**RESOLUTION SETTING HEARING REGARDING REQUEST FROM EASTGATE PLAZA, LLC (OWNER), REPRESENTED BY NORMAN S. WEINSTEIN, FOR REVIEW AND APPROVAL OF AN 8TH AMENDMENT TO EASTGATE PLAZA PUD CONCEPTUAL PLAN, ON PROPERTY LOCATED AT 1514 EAST EUCLID AVENUE, TO ALLOW A CAR WASH USE**

Communication from the City Plan and Zoning Commission advising that at their December 1, 2022 meeting, the following action was taken regarding a request from Eastgate Plaza, LLC (owner), represented by Norman S. Weinstein (officer), for review and approval of an 8th amendment to the Eastgate Plaza PUD Conceptual Plan on the property located at 1514 East Euclid Avenue, to allow a car wash use.

CITY OF DES MOINES, IOWA  
EASTGATE PLAZA PUD CONCEPTUAL PLAN  
- 8TH AMENDMENT  
PREPARED BY VJ ENGINEERING  
NOVEMBER, 2022

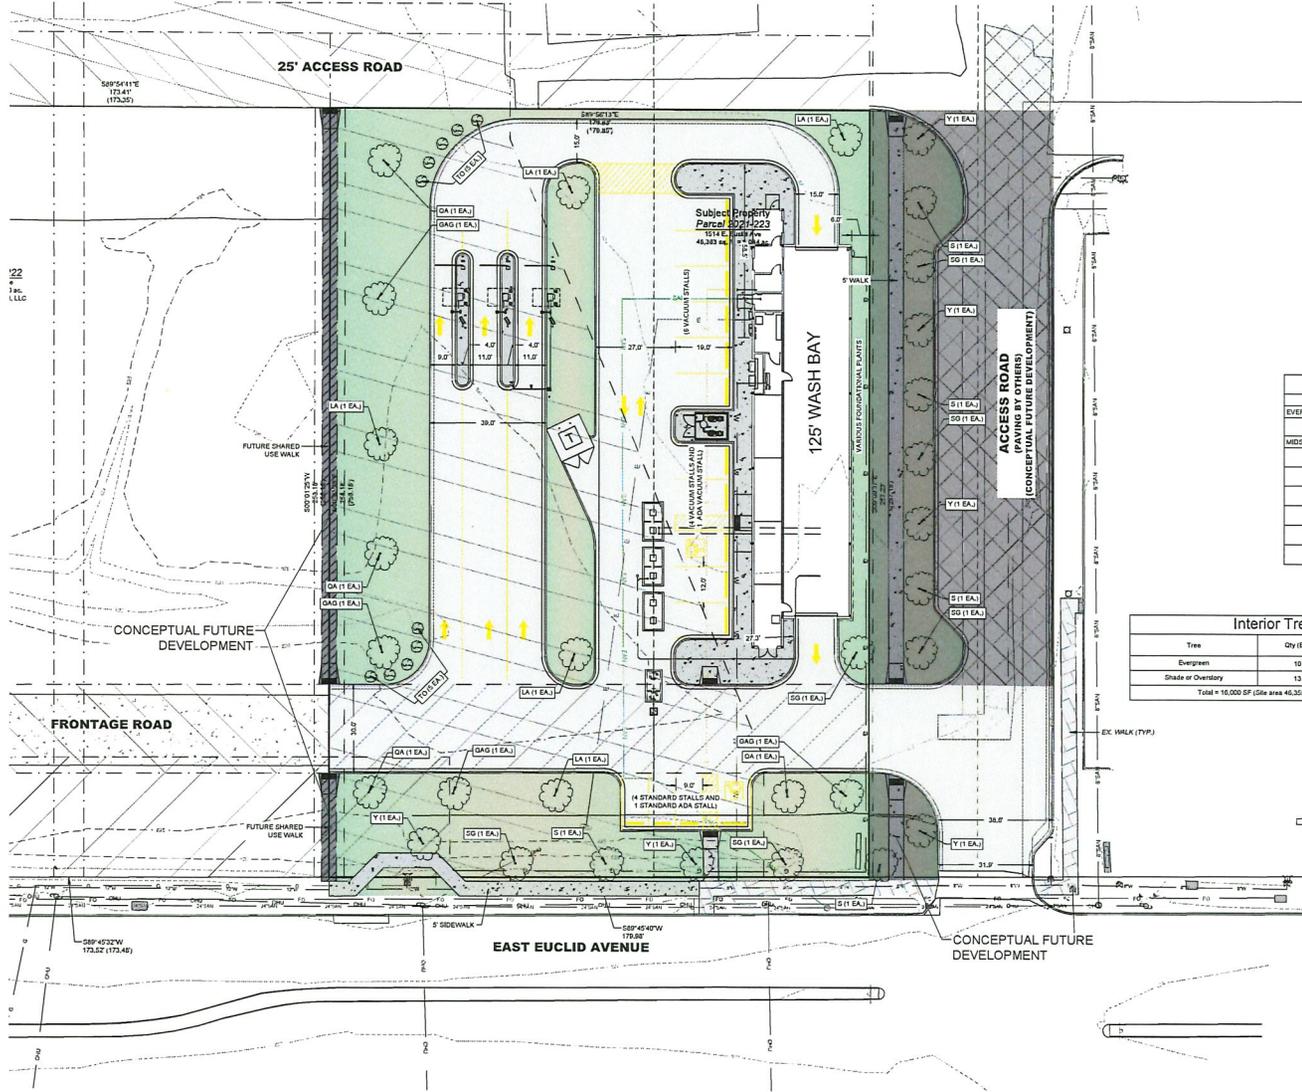
1. A note documenting any final design of the required “street-like” appearance of the 60-foot north/south drive easement shall occur at the time the adjacent property to the north is developed.

2. A note outlining time frame and responsibility of the north/south drive along the easterly line of the subject property, as determined, to the satisfaction of the Planning and Urban Design Administrator.

4. Foundation plantings shall be provided along the east facade of the building in addition to site plantings in accordance with Chapter 135, Article 7 (Planning and Design Ordinance), of the City Code, as required in the “MX3” District, and shall be reviewed and approved by the City’s Planning and Urban Design Division.
